On August 28, 1973, Mr. William H. Regan, Jr., Chief, Environmental Projects Branch 4, submitted to Carolina Power & Light Company the comments made on the H. B. Robinson Unit No. 2 Draft Environmental Statement by the Department of Health, Education, and Welfare, Environmental Protection Agency and the State of North Carolina. We have reviewed these comments and are providing you at this time with three (3) signed originals and 40 additional copies of our responses to these comments. Our responses to other agency comments were submitted to you by separate cover on September 18, 1973.

H. B. Robinson
Steam Electric
Plant Unit No. 2

REFERENCE LETTERS

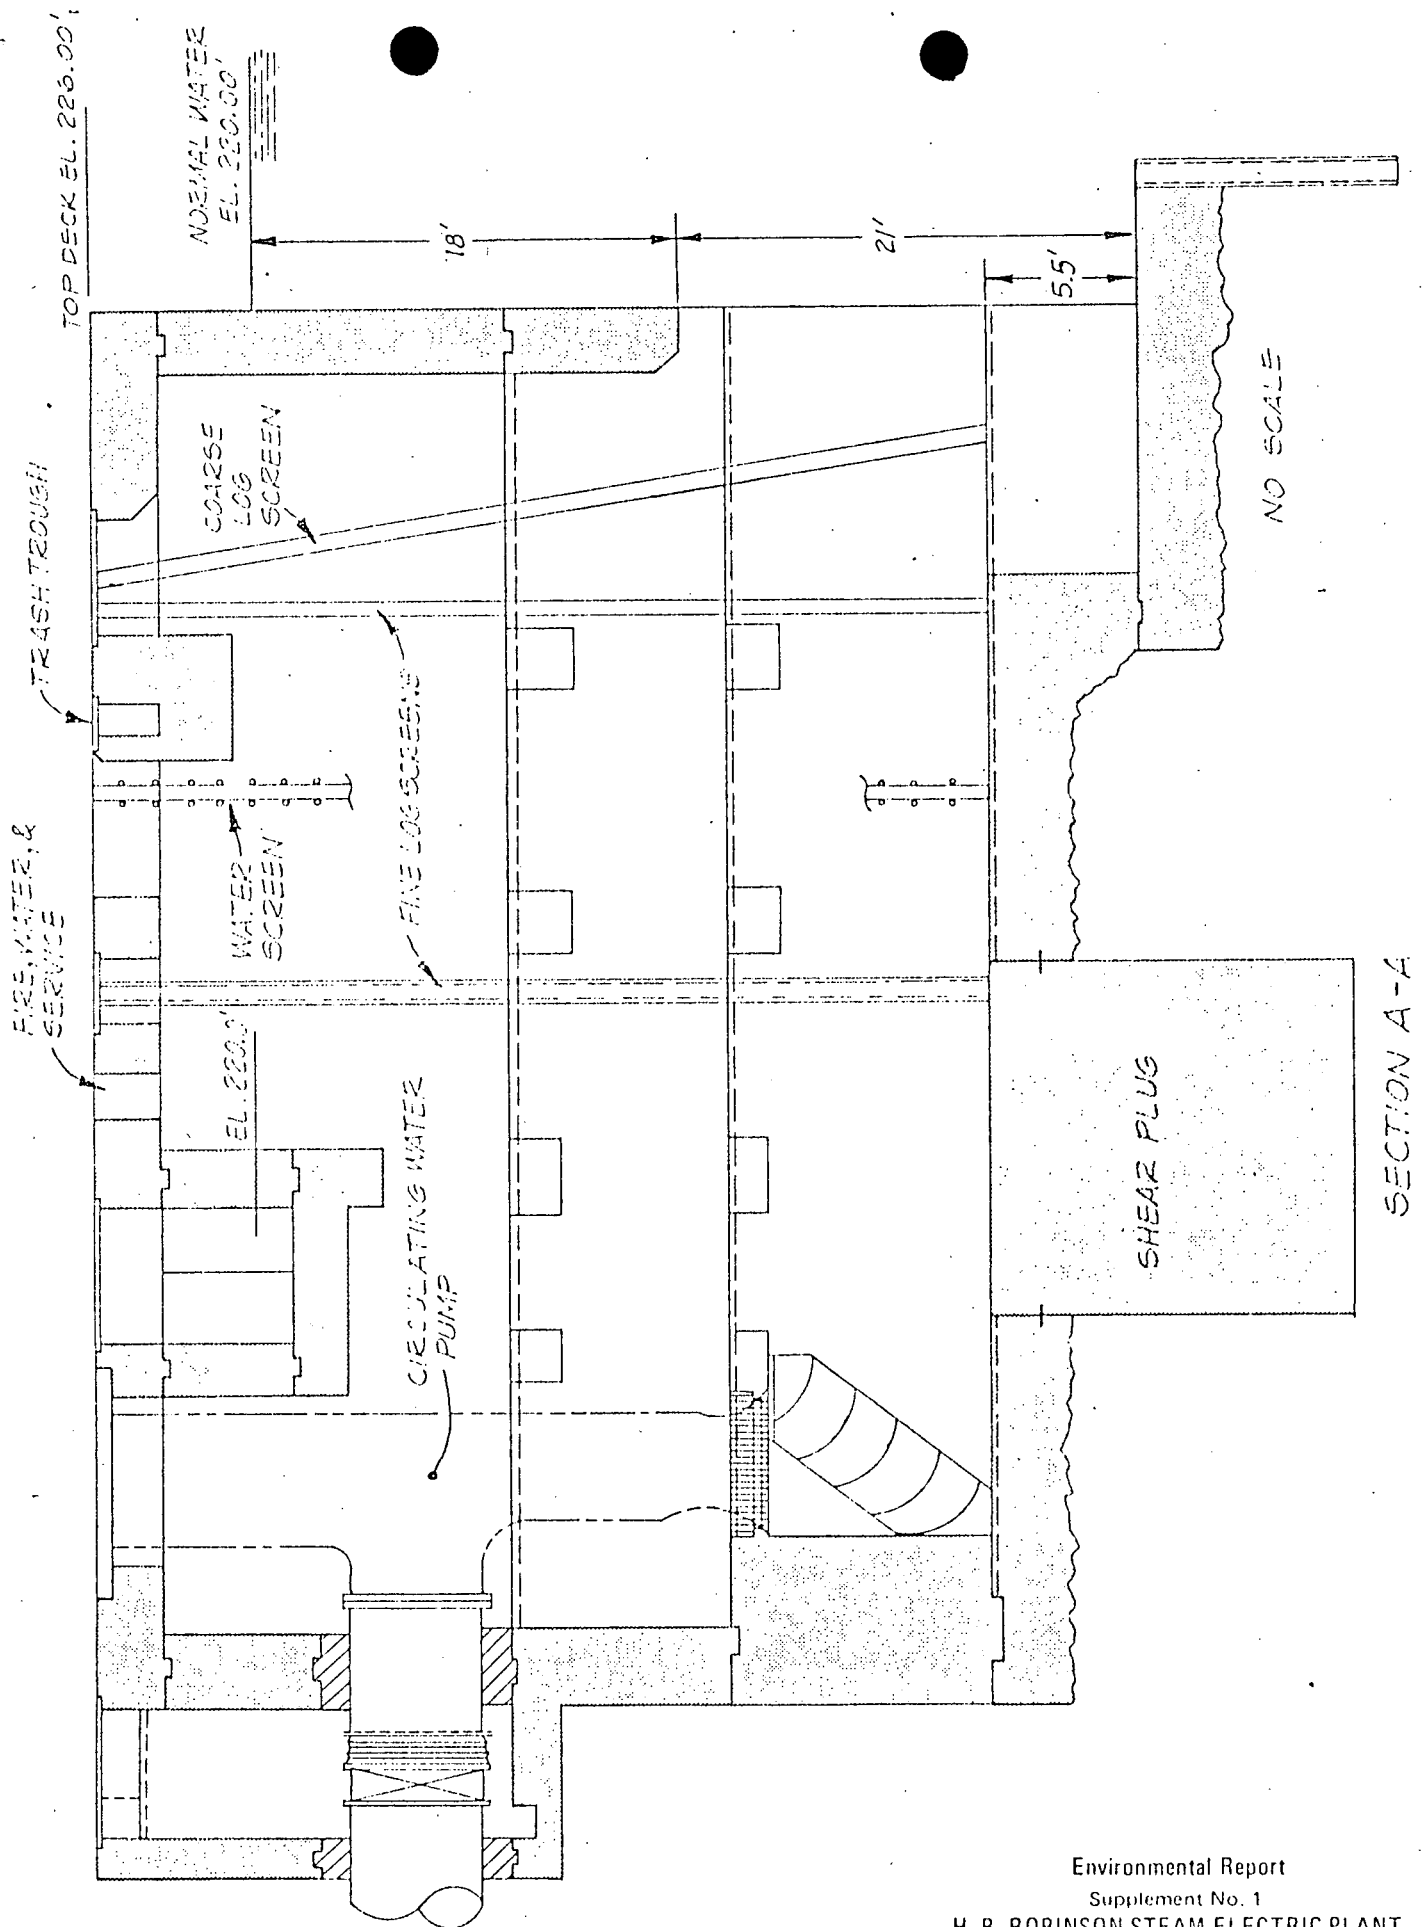
"The depth of penetration of the surface skimmer of the Unit 2 intake structure is not shown in either Figure 3.4 or 3.5. Since skimmers extend from the surface to varying depths, they control the depth from which incoming water is taken and therefore, its characteristics. The depth and impact of the Unit 2 skimmer should be discussed in the final statement." (Reference 1, page 15)

The revised figure is shown on the following page. The bottom of the skimmer wall is 18 feet below the lake surface; thus, water is continuously withdrawn from near the bottom.
